November 19, 2024

Please see below for comments from the Port of Seattle (“Port”) on the Boeing Isaacson-Thompson Site (“Site”) Agreed Order (“AO”) and Cleanup Action Plan (“CAP”) draft documents out for public comment. First, we provide general comments regarding the Site and the draft documents. Following that is a table providing specific comments, identified by sections within the documents. Above all, the Port emphasizes that the Port Sliver bulkhead or physical landmass need not be reconstructed following remediation.

Comment	Section	Comment
<p>2002</p>  <p>Fence Lines Established</p>		<p>2003</p>  <p>Fence Lines Present</p>

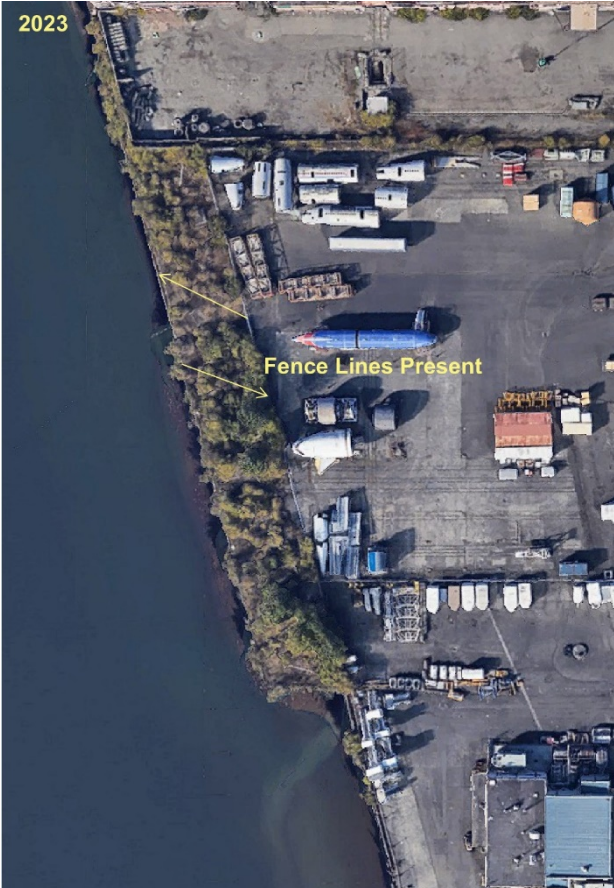
Comment	Section	Comment
1	dCAP Section 2.0	Update text to explain that the chain-link fence was installed between 1998 and 2002 based upon available imagery. See provided aerials from 1985 (USGS), 1998 (WA DNR), 2002 (Google Earth), and 2023 (Google Earth).
